TLR/RES/DE/CIB-2020-13

**Technical Input for the U.S. Nuclear Regulatory Commission Review  
of the 2017 Edition of ASME Boiler and Pressure Vessel Code,  
Section III, Division 5, “High-Temperature Reactors”**

**HBB-T, HBB-II, HCB-I, HCB-II, and HCB-III for Metallic Components**

December 2020

**Figure 4.2.2-1 Values of  $S_y$ ,  $S_u$ , and  $S_m$  for SA-533 and SA-508 materials confirming that the  $S_m$  values for  $T > 700$  degrees F (371.1 degrees C) are an extension of those for  $T < 700$  degrees F (371.1 degrees C) and are conservative**

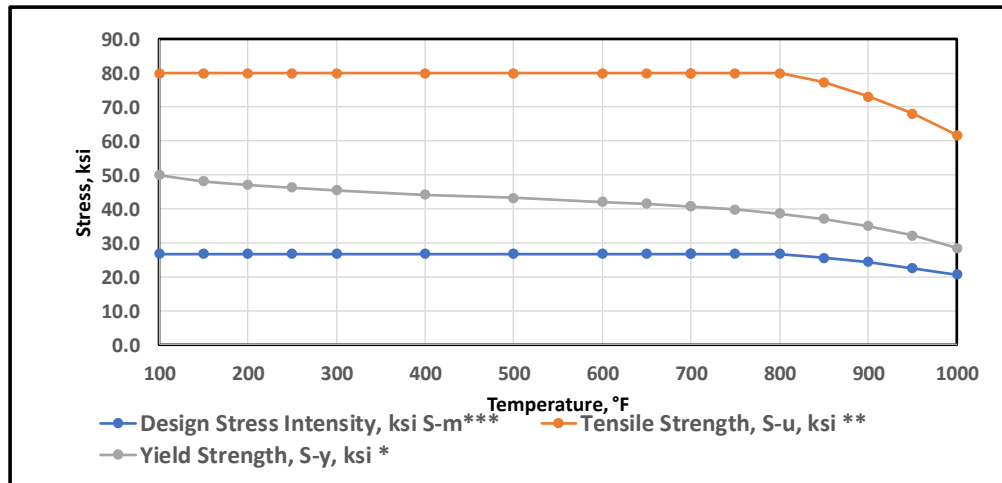
Figure 4.2.2-1 shows the values of  $S_m$ ,  $S_y$ , and  $S_u$  for the two materials (which are identical) as seen in Table 4.2.2-1. As may be noted in Table 4.2.2-1, the margin of safety ( $S_u/S_m$ ) for both materials for the entire range of temperatures is consistently 3.0, thereby confirming that the  $S_m$  values in Table HBB-II-3000-3 are both conservative and an extension of those values provided in ASME BPVC Section II, Part D, Subpart 1, as stated in Mandatory Appendix HBB-II-2000. Article HBB-II-2000 is therefore recommended for endorsement.

**Figure 4.2.3-1 Creep-rupture data from ORNL (1989) and INL (2014) compared with values in Table HBB-II-3000-4 (Note: The stress values in the original reports were reported in MPa and are therefore shown in these units.)**

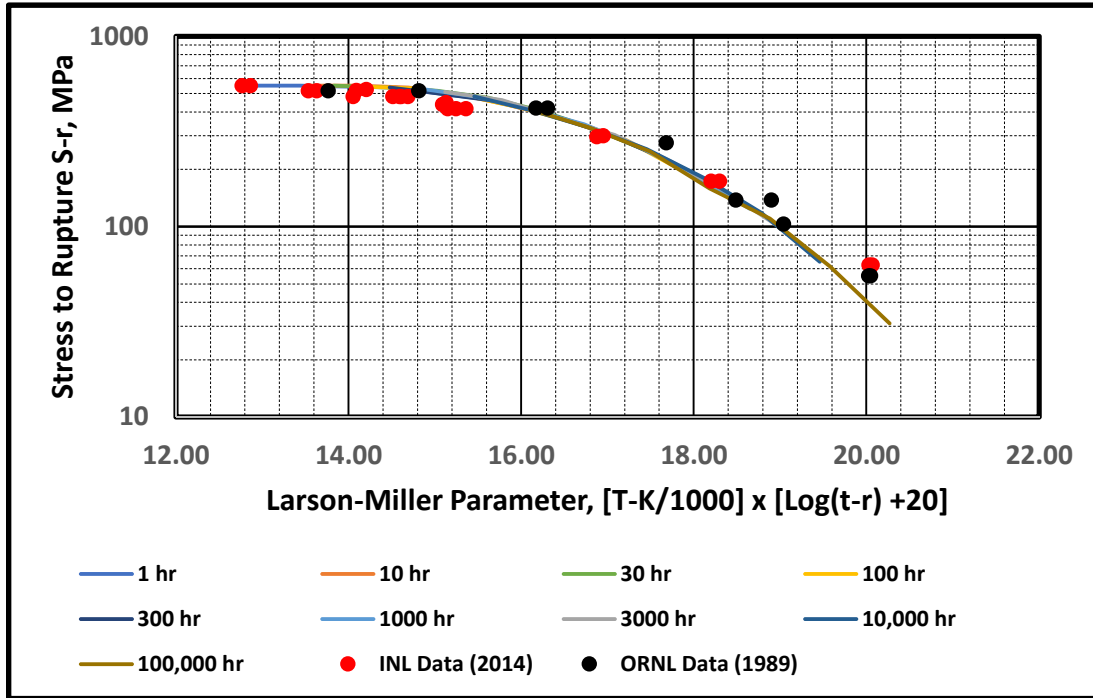
Laboratory (INL) by Wright (2014). While the final reports from these two studies were not available, the interim reports were available and were reviewed in detail. Figure 4.2.3-1 shows these data compared with the minimum stress-to-rupture values ( $S_r$ ) from Table HBB-II-3000-4 on a standard Larson-Miller (L-M) parameter plot (see Wright, 2014), which is frequently used to normalize creep-rupture data for time, temperature, and stress as explained below.

**Figure 4.2.3-2 Comparison of HBB-II isochronous curves with ORNL data (1989) at 800 degrees F (426.7 degrees C) at 100 hours; 900 degrees F (482.2 degrees C) at 300 hours; and 1,000 degrees F (537.8 degrees C) at 300 hours**

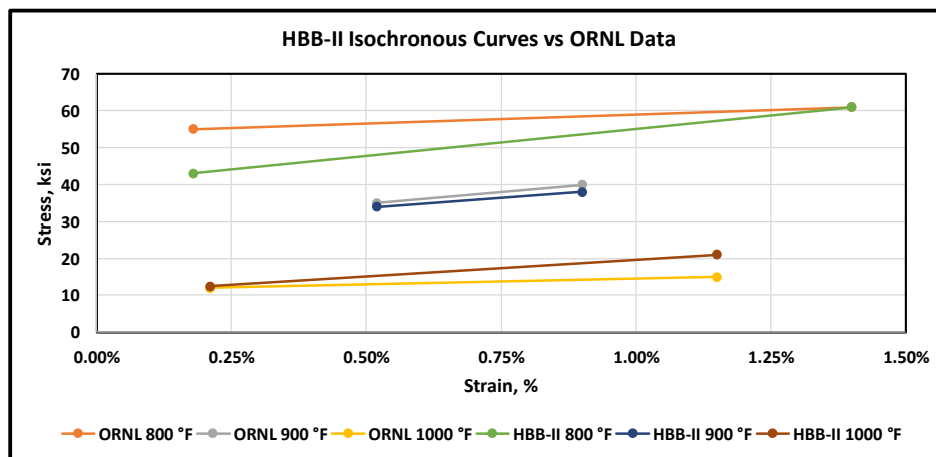
The next step was to do some very limited comparisons between the creep data from ORNL (McCoy, 1989) with the isochronous curves above, since the data are presented in tabular format with only the time to reach 0.1 percent, 1.0 percent, and 2.0 percent strain at four temperatures (700 degrees F, 800 degrees F, 900 degrees F, and 1,000 degrees F (371.1 degrees C, 426.7 degrees C, 482.2 degrees C, and 537.8 degrees C)) at only two stress levels for each case for only one lot (Lot 3) of the materials. These limited ORNL data were used to interpolate and obtain values for the isochronous stress-strain curves at three temperatures—800 degrees F (426.7 degrees C) at 100 hours, 900 degrees F (482.2 degrees C) at 300 hours, and 1,000 degrees F (537.8 degrees C) at 300 hours—for comparisons to HBB-II curves above. Figure 4.2.3-2 below shows that the comparison between HBB-II and the ORNL data are reasonable. Given this confirmation and the fact that the minimum fracture strain to failure under creep rupture was 18 percent as discussed above, the proposed isochronous curves in HBB-II are recommended for endorsement.

**Figure 4.2.3-3 Design fatigue strain range for SA-533 and SA-508 from Figure HBB-II-3000-11 compared to those for 2.25Cr-1 Mo and Alloy 800H steels from HBB-T**

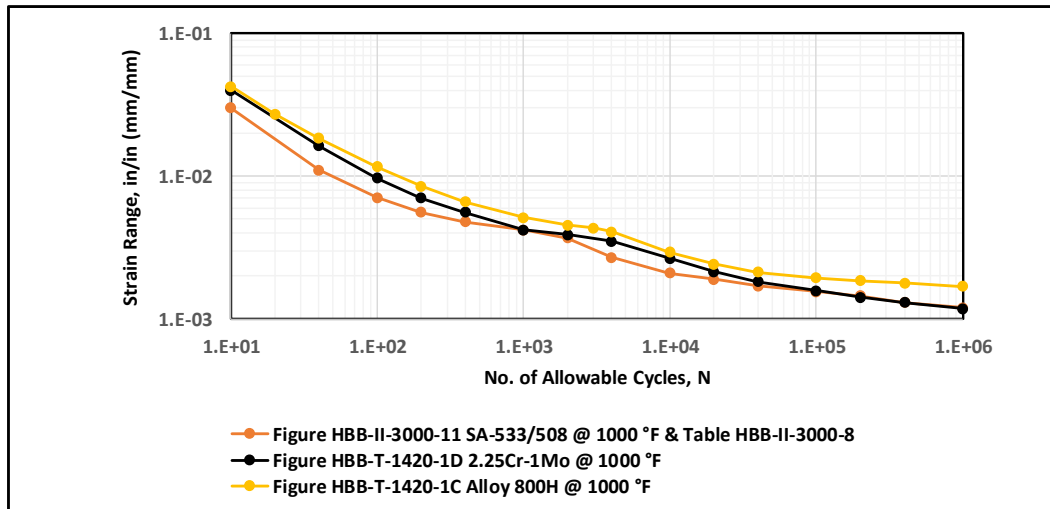
- Figure HBB-II-3000-11, and Figure HBB-II-3000-12, that describe the design fatigue strain range and creep-fatigue damage envelope respectively, for the two materials covered by this appendix may need further clarification. As discussed in Section 4.2.3 below, these figures appear to be based on the methodology described in HBB-T-1400 for the 2.25Cr-1Mo and Alloy 800H. HBB-II-3000(i) needs to reference HBB-T-1400 for the methodology adopted and state that the approach using the basis for 2.25Cr-1Mo and Alloy 800H provides a conservative lower bound for the analyses for the two materials in this appendix.

There is a discussion of creep rupture of cyclic damaged specimens and limited data in the INL report by Wright (2014), but that cannot be used to validate Figures HBB-II-3000-11 and HBB-II-3000-12. However, on close examination, these two figures appear to be derived from HBB-T-1400 for the 2.25Cr-1Mo and Alloy 800H steels (perhaps this is because they are most similar to the SA-533 and SA-508 materials). Figure 4.2.3-3 shows a comparison of HBB-II-3000-11 design fatigue strain range curves with those presented in Figures HBB-T-1420-1C and HBB-T-1420-1D.

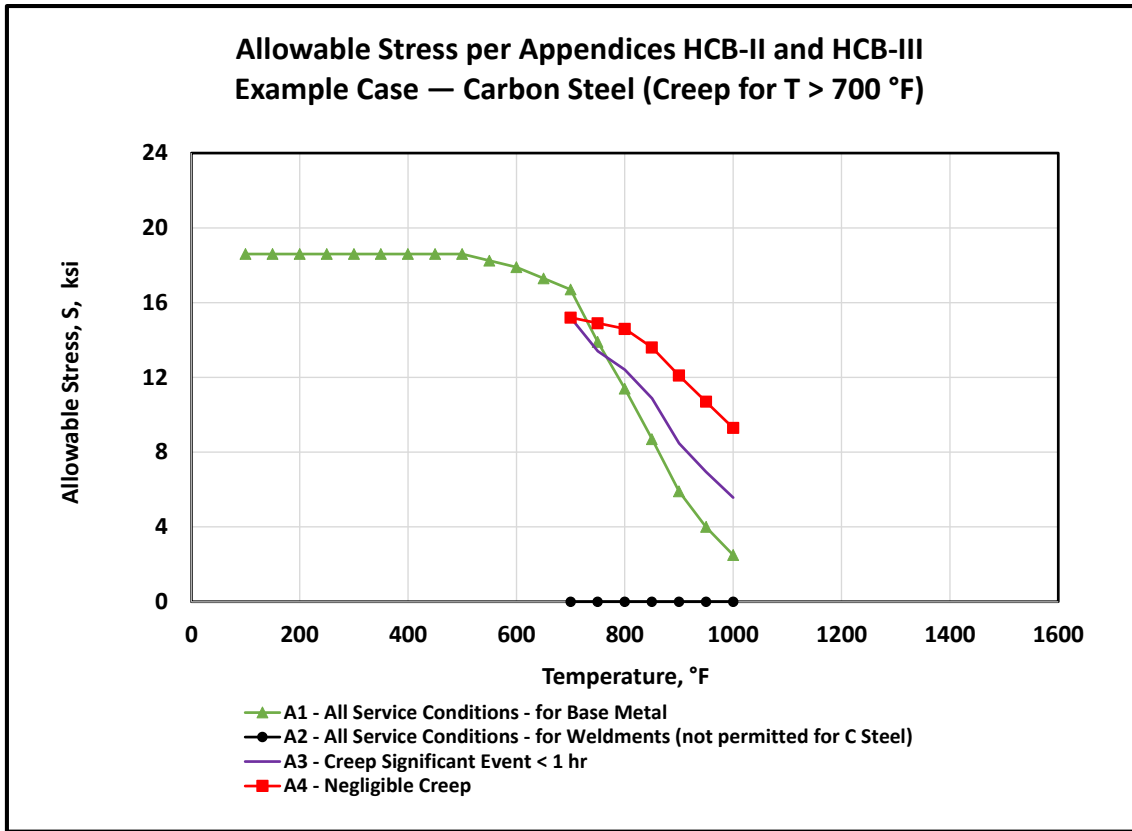
- The relative values of the two sets of curves for allowable stresses for A1 and A2 versus A3 and A4 appear to be inconsistent for several of the cases as noted above. For the example case selected for carbon steel (Figure 4.4.2-1), low-alloy steel (Figure 4.4.2-2), and Grade 91 (Figure 4.4.2-3), the allowable stress curves for cases A3 and A4 are lower than those for A1 and A2 at 700 degrees F (371.1 degrees C). For 304 SS (Figure 4.4.2-6) and 316 SS (Figure 4.4.2-7), the A3 and A4 stresses are higher than those for A1 and A2 at 800 degrees F (426.7 degrees C) and, therefore, could be nonconservative. For the remaining cases, Cast 304 SS (Figure 4.4.2-4), Cast 316 SS (Figure 4.4.2-5), and Alloy 800H (Figure 4.4.2-8), the curves appear to be consistent at 800 degrees F (426.7 degrees C); that is, the values for allowable stresses for A3 and A4 are in line with those for cases A1 and A2.

- As described above, there are cases where the allowable stresses as determined for Designator A4 are lower than those for Designators A1 and A2. If users decide to follow the path in Figure HCB-II-1000-1 to determine and apply the allowable stresses for Designators A1 and A2, they may not actually be using the most conservative value of the allowable stress and would not be in compliance with the BPVC. In light of the above inconsistencies, which ASME will need to resolve, this review recommends that the most conservative value of the allowable stress be used in every case.

**Figure A-6 Comparison of calculated BPVC-III-5 isochronous curves for 304 SS at 649 degrees C (1200 degrees F) to data points from the NIMS database.**

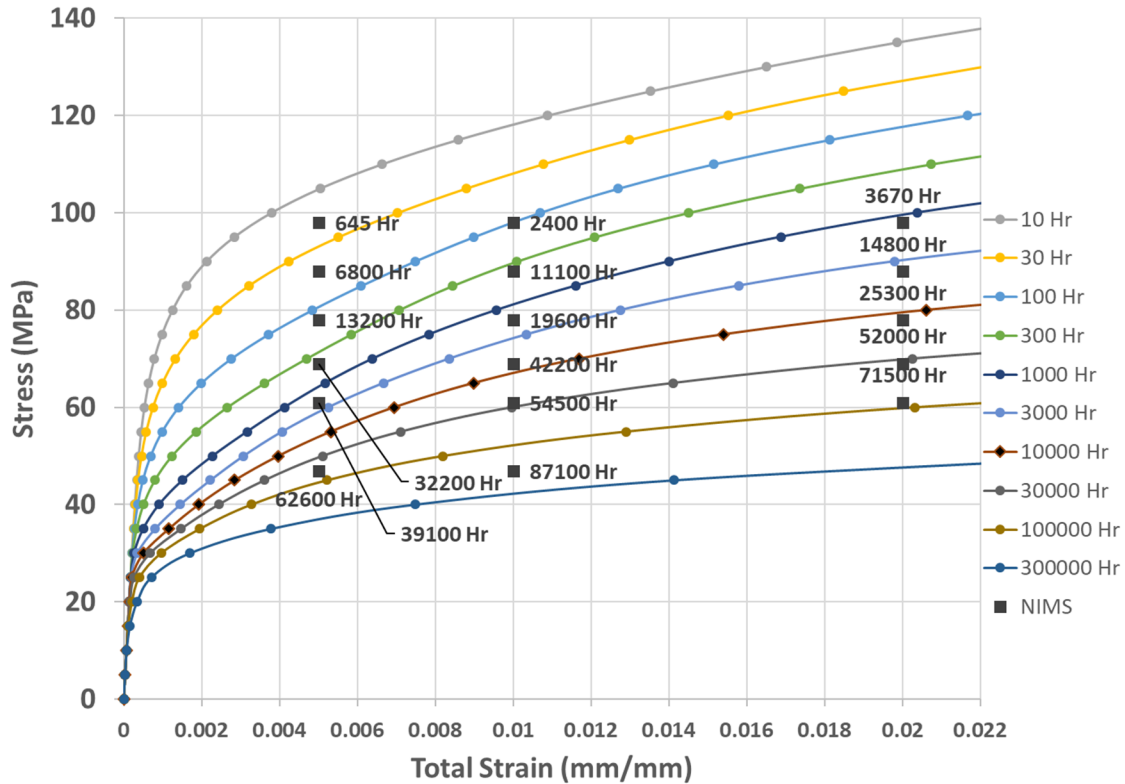
As seen in Figure A-6 for 304 SS at 649 degrees C (1200 degrees F), the NIMS data are plotted as points with the time to reach the various strain levels listed (e.g., the 645-hour NIMS data point at a stress of 98 MPa and a creep strain of 0.005 millimeter (mm)/mm). This point falls close to the isochronous data curve for 10 hours from BPVC-III-5. Since the 100-hour curve is below this point, this means that the code creep values are conservative.

**Figure A-7 Comparison of calculated BPVC-III-5 isochronous for 304 SS curves at 700 degrees C (1292 degrees F) to data points from the NIMS database.**

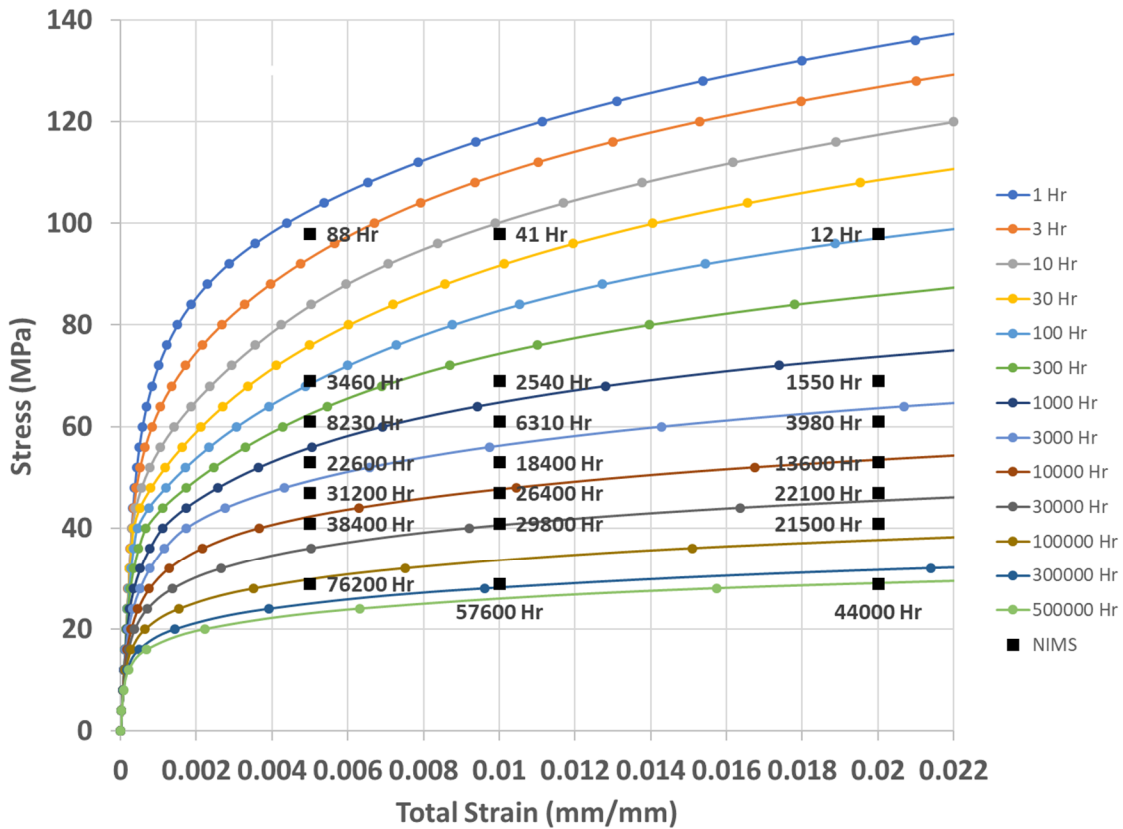
Likewise, Figure A-7 compares the isochronous stress-strain curves of BPVC-III-5 to NIMS data at 700 degrees C (1292 degrees F). Again, the code curves are conservative compared to the new data for all times except when longer times are considered. For example, a NIMS data point at 29 MPa with creep strain of 0.02 mm/mm (76,200 hours) falls on the isochronous creep curve of the code for the time of 500,000 hours. Similar NIMS data points also fall below curves at longer times.

**Figure A-12 Calculated isochronous stress-strain curves for 316 SS at 649 degrees C (1200 degrees F) (Figure HBB-T-1800-B-9) compared to data from the NIMS database and Sikka et al. (1980).**

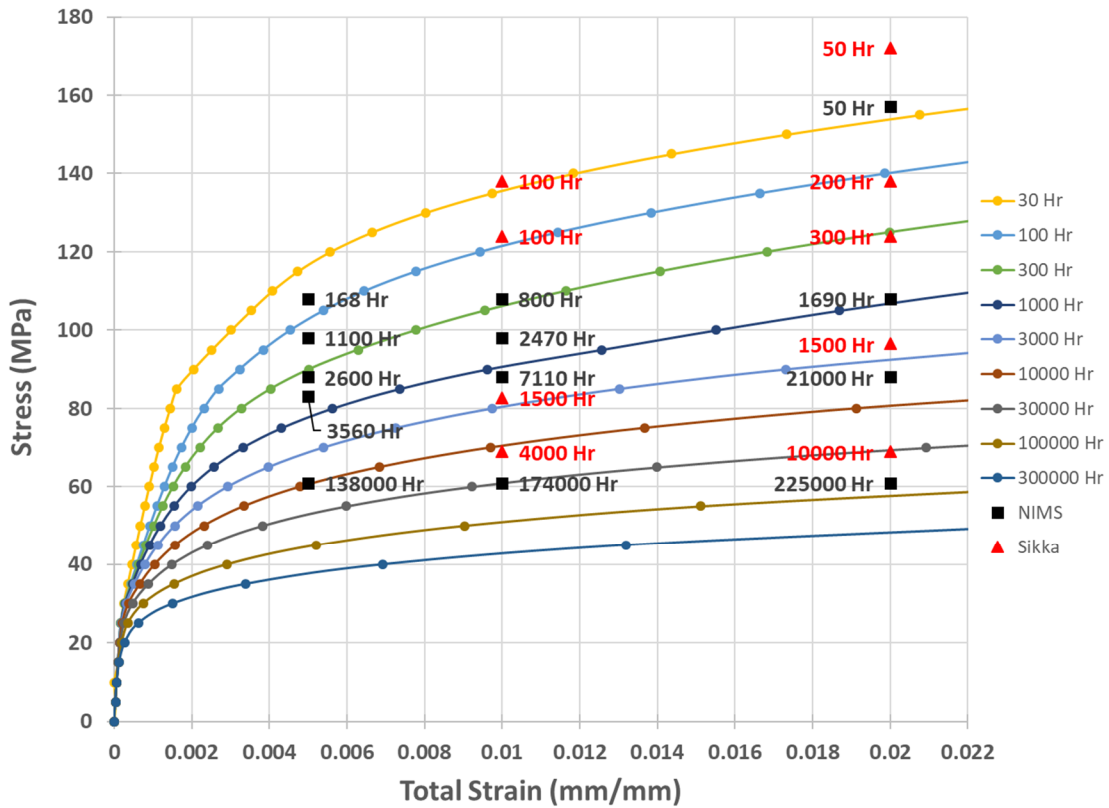
Figure A-12 compares the code isochronous curves with NIMS data and that from Sikka et al. (1980) at 649 degrees C (1200 degrees F) from 13 heats of material. All of the NIMS data are above the code-based curves for all times, indicating that the code curves are conservative at this temperature. Note that there is a datum point from the NIMS data for a time of 225,000 hours (61 MPa) that lies just above the 100,000-hour code curve. This indicates that the extrapolation in the code of the creep isochronous curves to long times is quite conservative at this temperature. Comparisons of the curves to the Sikka et al. data are a little non-conservative at longer times. For example, the Sikka et al. datum point of 0.02 strain at a stress of 69 MPa for 10,000 hours is approximately what the code would predict at 30,000 hours. The Sikka et al. data were extracted from hand plots of creep strain accumulation versus time, and there may be some error in this interpretation.

**Figure A-13 Calculated isochronous creep stress-strain curves for 316 SS at 750 degrees C (1382 degrees F) compared to data from the NIMS database and Sikka et al. (1980).**

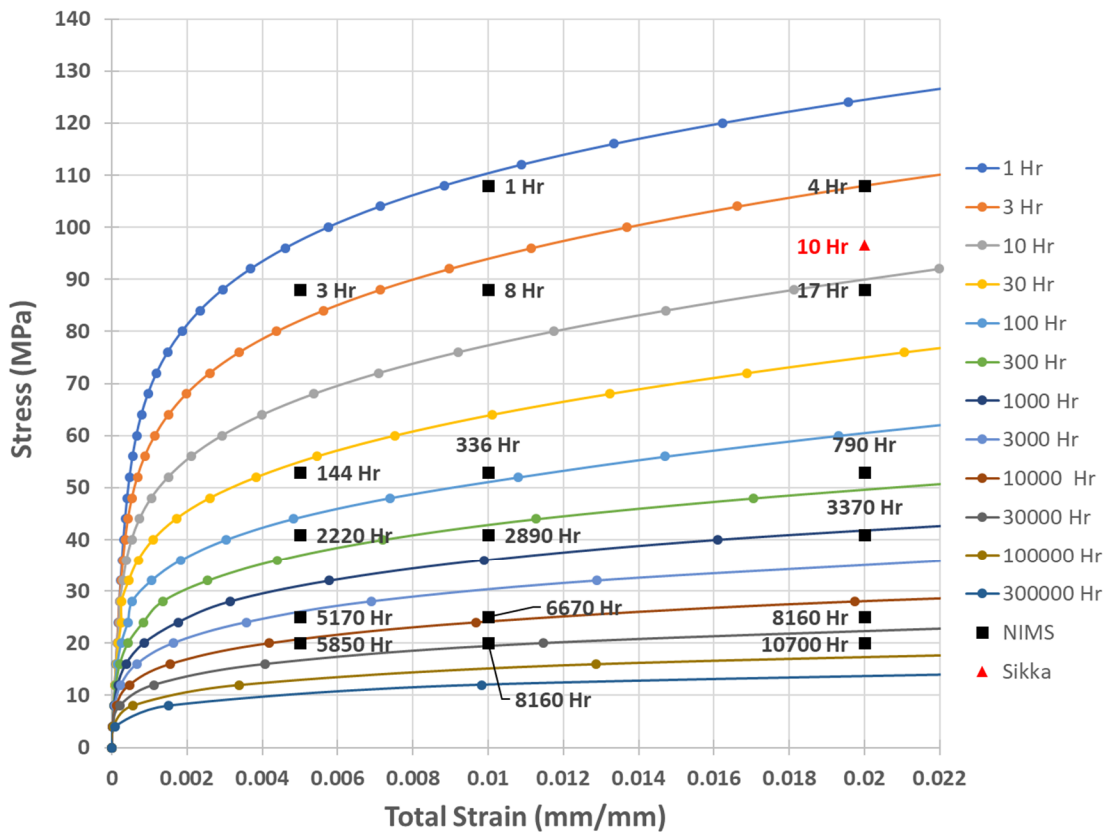
Figure A-13 compares the creep strains obtained from the NIMS database and one point from Sikka et al. to the code-based isochronous curves at 750 degrees C (1382 degrees F).<sup>2</sup> The code curves are conservative for all times less than about 1,000 hours. Several NIMS data points are nonconservative for times greater than 3,000 hours.

**Figure A-21 Comparison of calculated code isochronous curves for 2.25Cr-1Mo at 600 degrees C (1112 degrees F) with data from NIMS database.**

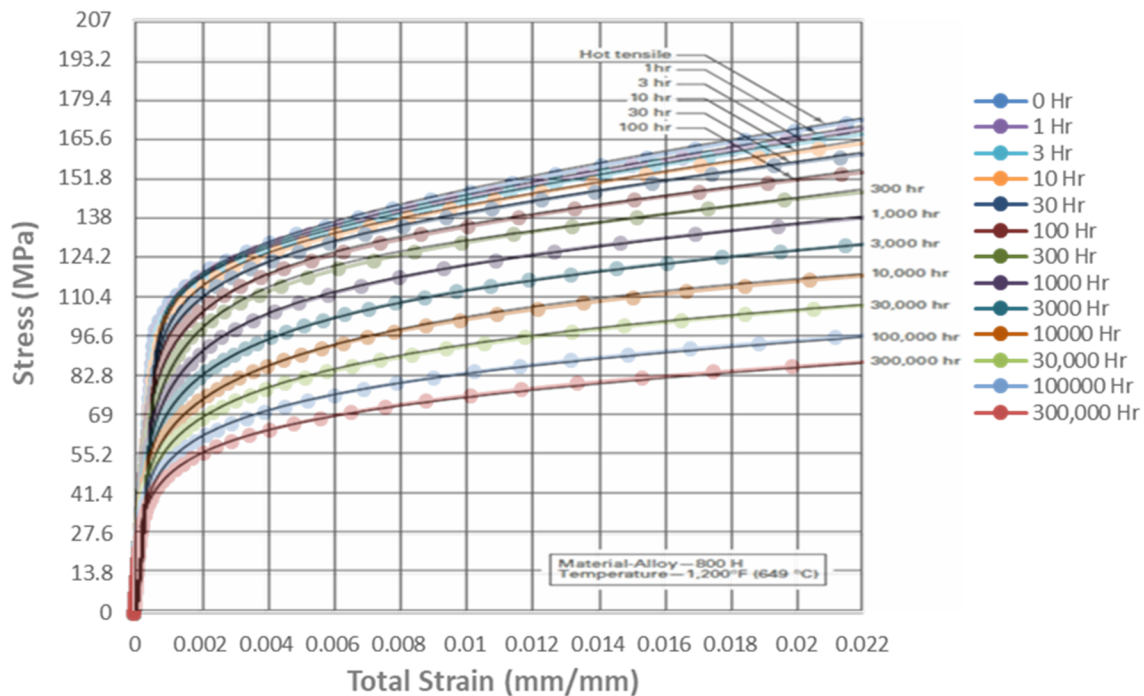
Finally, Figure A-21 compares NIMS data points with the BPVC-III-5 creep isochronous curves at 600 degrees C (1112 degrees F). The code curves go up to a maximum temperature of

649 degrees C (1200 degrees F) for this material, and this is the highest temperature for which data were found. The BPVC-III-5 isochronous creep at this high temperature is still conservative for most times. However, the NIMS data points, some of which came from creep tests carried out for long times, are lower than the code curves for long time periods. For example, the NIMS data point at 104,000 hours lies on the 300,000-hour isochronous curves. This suggests that the code curves are not conservative for long time periods and high temperatures.

Figure A-24 Comparison of calculated code isochronous curves for Alloy 800H at 700 degrees C (1292 degrees F) to data from the NIMS database.

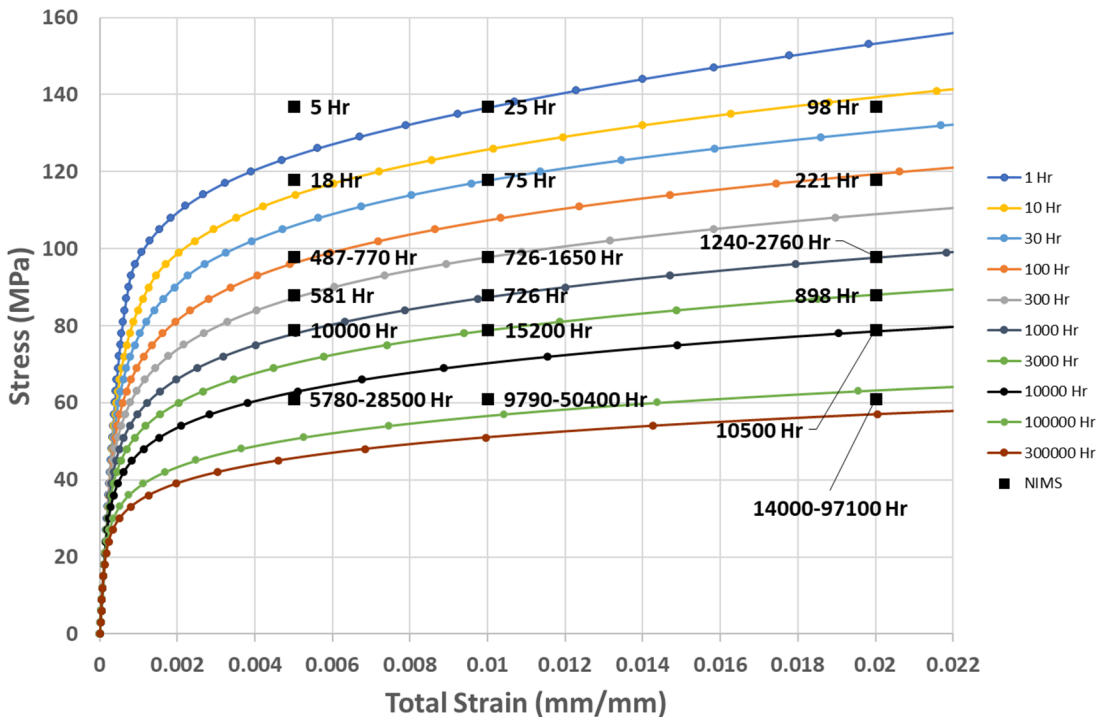
Figure A-24 compares some NIMS data with BPVC-III-5 curves at 700 degrees C (1292 degrees F). For the NIMS data, tests were performed at the same stress, with the time to the given strain given as a range. For example, at 98 MPa at 0.01 strain, the time range was 903 to 1,650 hours. At 61 MPa at 0.02 strain, the time range is 14,000 to 97,100 hours. This illustrates the large scatter in creep data that results in the isochronous curves. This latter data point is near the isochronous curve of 100,000 hours, and some of the data may be nonconservative. The NIMS data used in Figure A-24 is also provided in Table A-1 shows the variability in creep data.

Based on Figure A-24 and Table A-1, the isochronous curves for Alloy 800H material at 700 degrees C (1292 degrees F), may be nonconservative at times of 100,000 hours and above.
